**MAINE DEPARTMENT OF  
INLAND FISHERIES AND WILDLIFE**

**ADDENDUM NO. 3**

**PHASE III FACILITY CONVERSION AT NEW GLOUCESTER STATE FISH HATCHERY**

BGS PROJECT NO.: 3289-312

**26. SHEET 04D-404**

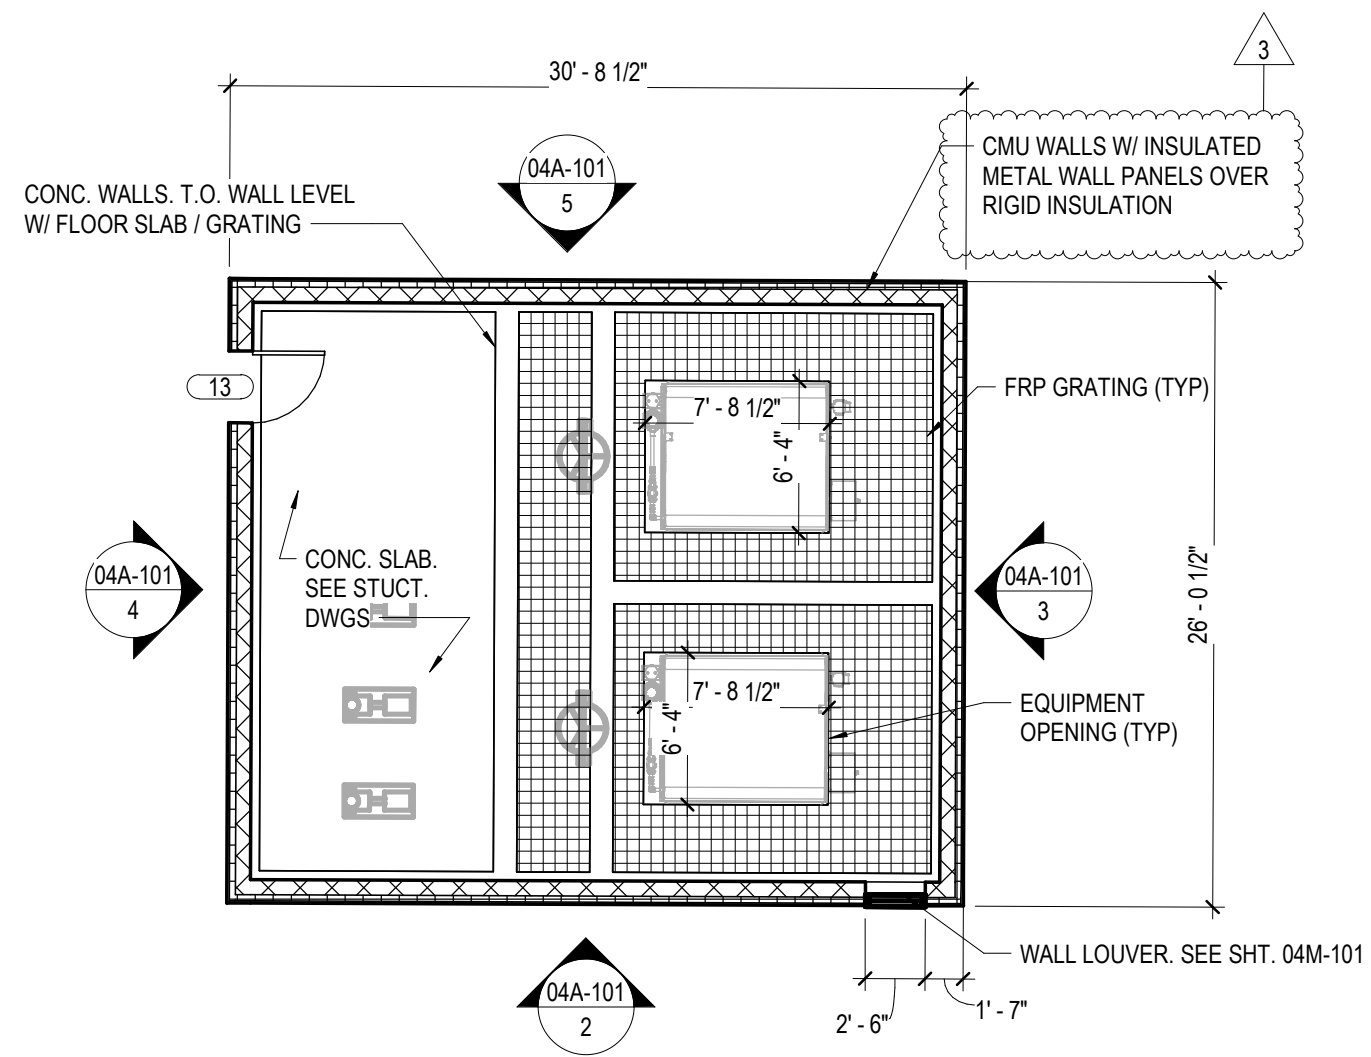
- a. **REPLACE:** Section 2: Twice “6-inch SLU CL 230.30”  
**WITH:** “6-inch SLU CL 230.19”  
**REPLACE:** “6-inch WDW CL 232.95”  
**WITH:** “6-inch WDW CL 230.42”

**EFFLUENT TREATMENT BUILDING PLAN AND ELEVATIONS**

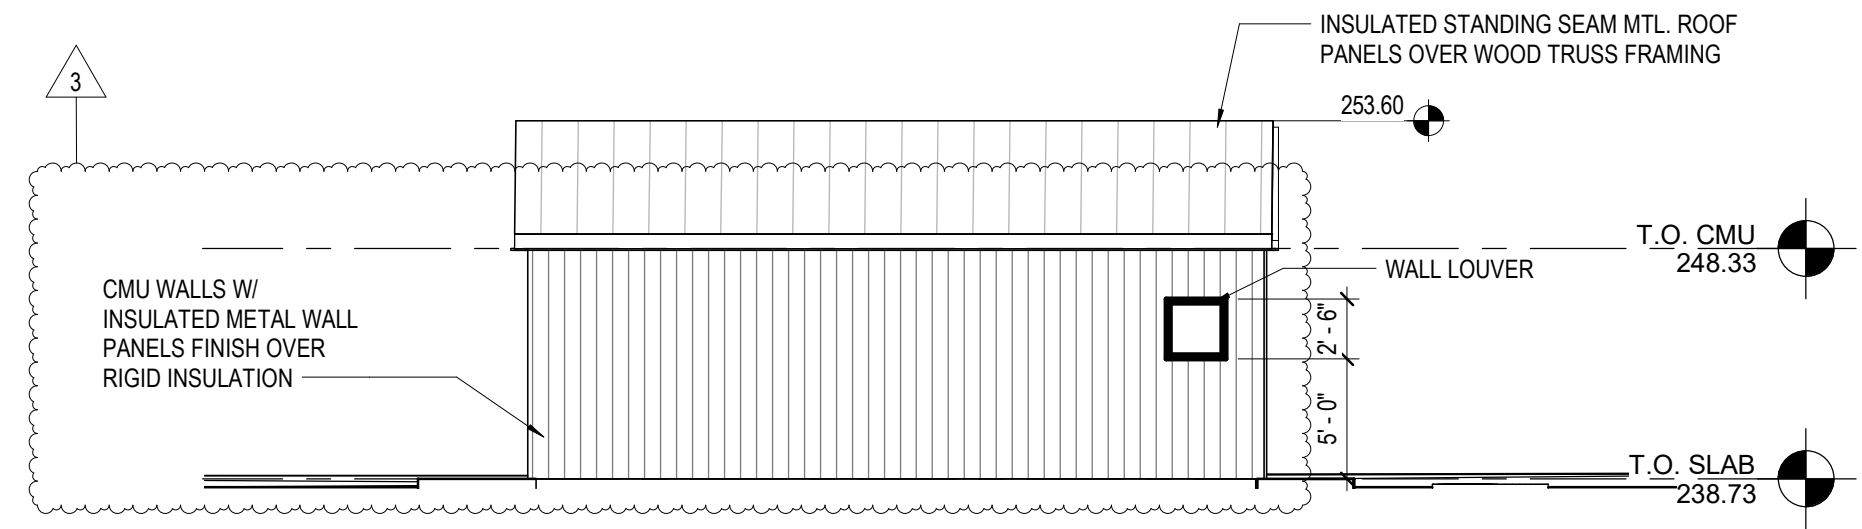
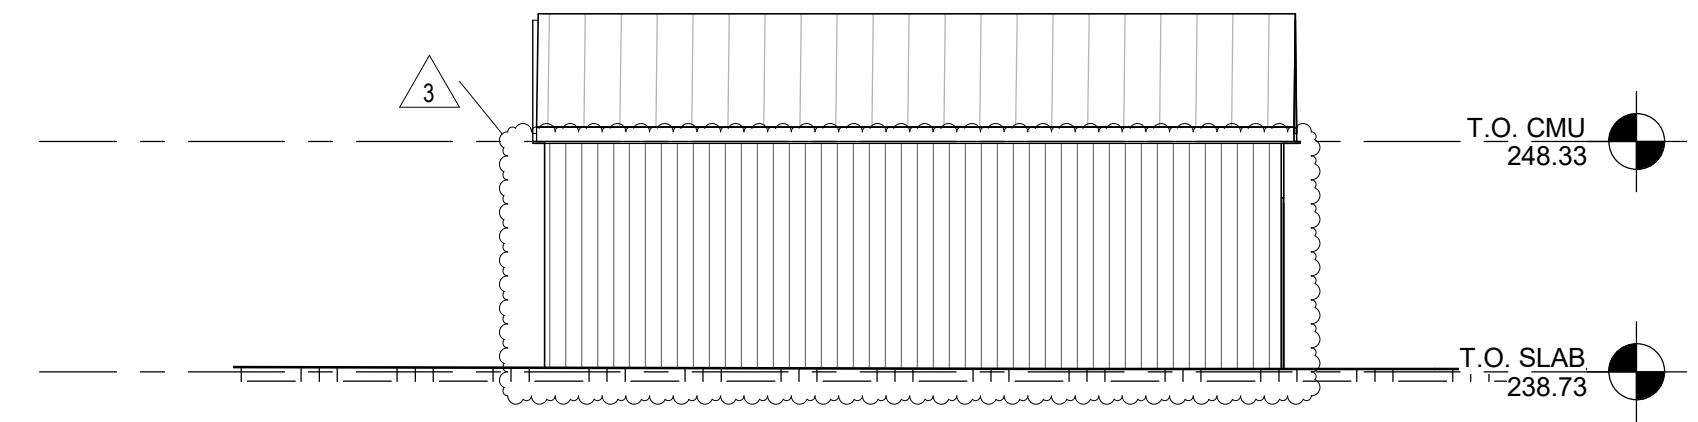
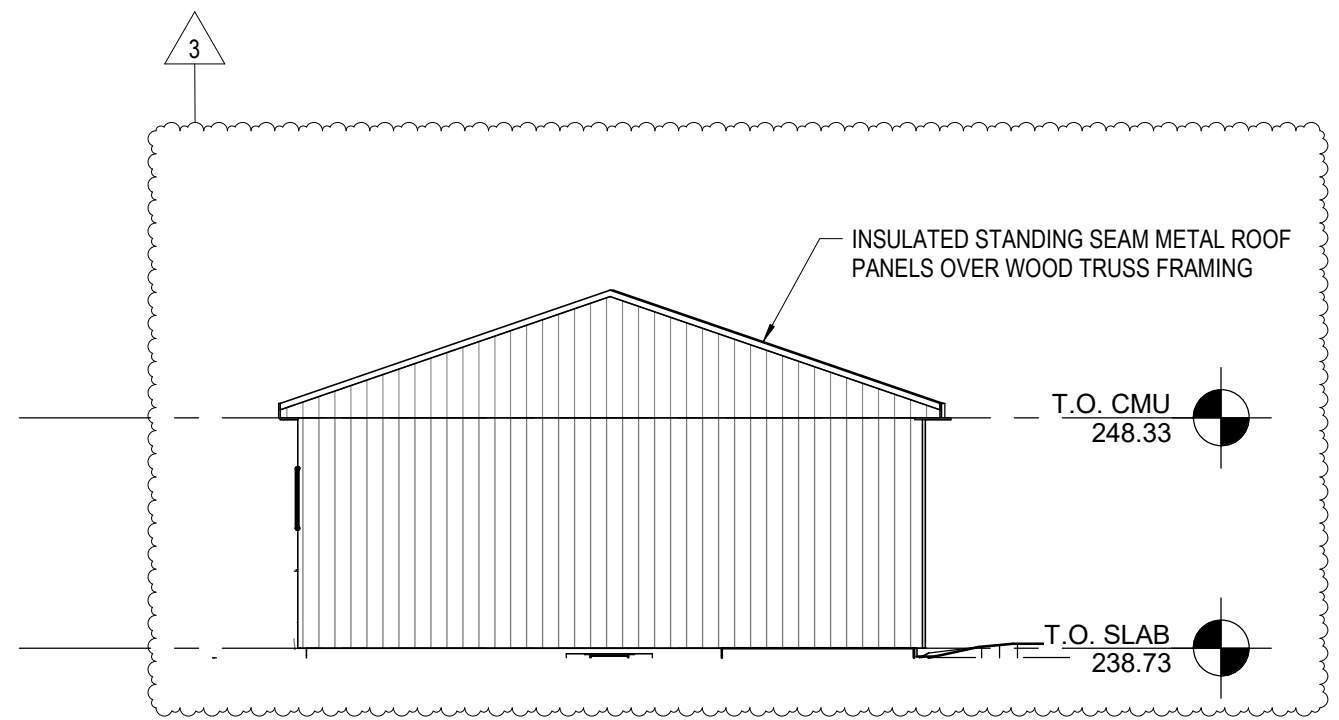
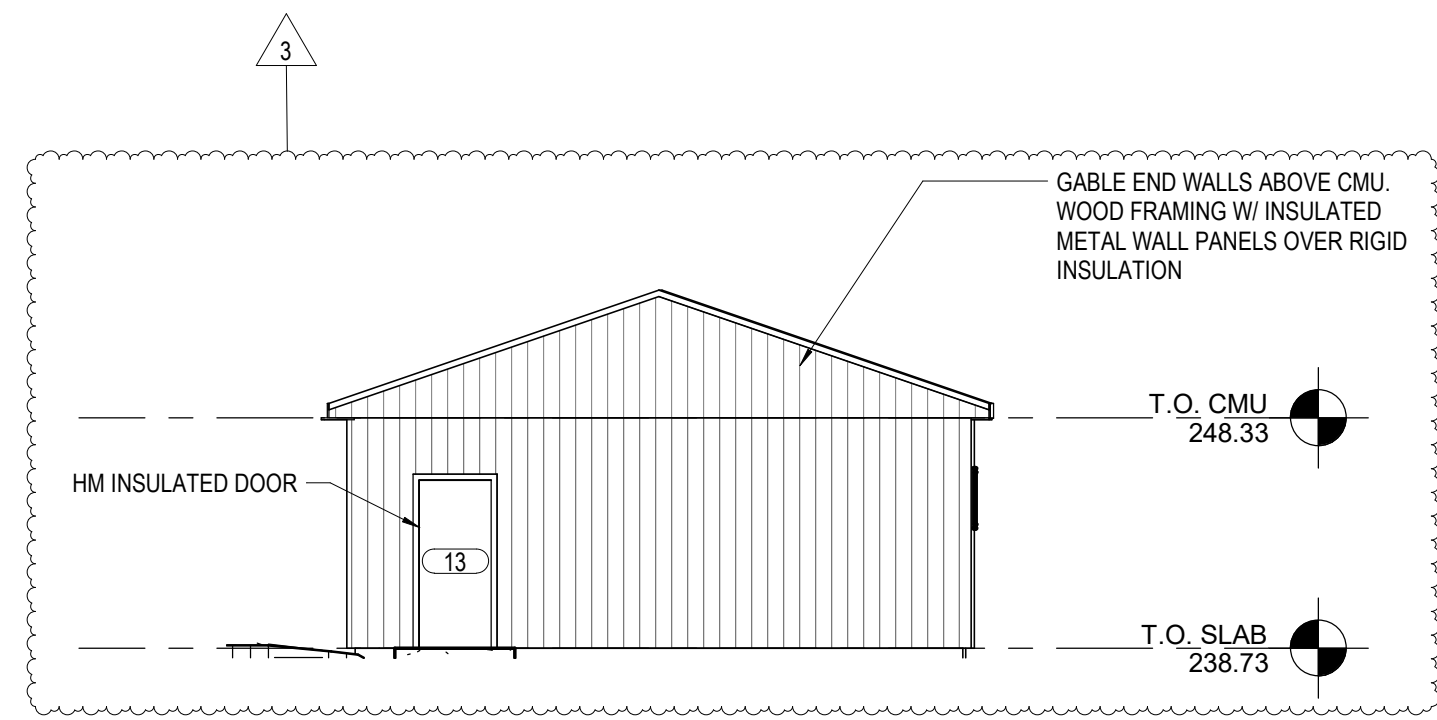
- 4. QUESTION:** The wall sections on 04S-302 show “rigid insulation with architectural wall finish” over the CMU exterior walls. The exterior elevations on 04A-101 show exterior walls as CMU. Please clarify the exterior wall required materials system.

- 5. QUESTION:** The exterior gable walls have no reference to exterior wall requirements above the CMU walls. Please clarify the wall requirements at this condition.

- 6. QUESTION:** There is no door schedule for the exterior door 13 at the Effluent Treatment Building. Please provide.  
**ANSWER:** See Part 3 for update.

**21. SHEET 04A-101: ATTACHED**

- a. **ADD:** See Below for schedule.

DOOR AND FRAME SCHEDULE																	
LEVEL	IDENTIFICATION			DIMENSIONS					DOOR TYPE	PANEL		FRAME			FIRE RATING	HARDWARE GROUP	NOTES
	ROOM NO.	ROOM NAME	DOOR NO.	OPENING WIDTH			H	T		Material	Finish	TYPE	Material	Finish			
				W1	W2	Total Width											
T.O. SLAB	400	UPPER LEVEL	13	-	-	4'-0"	7'-0"	1 3/4"	D03	METAL	PAINTED	F05	METAL	PAINTED	N/A	2

- b. **UPDATE:** Detail 1 & 2: The exterior walls will be insulated metal wall panels (architectural wall finish) over rigid insulation on CMU.
- c. **ADD:** Detail 4 – Callout: “GABLE END WALLS ABOVE CMU WOOD FRAMING W/ INSULATED METAL WALL PANELS OVER RIGID INSULATION”.
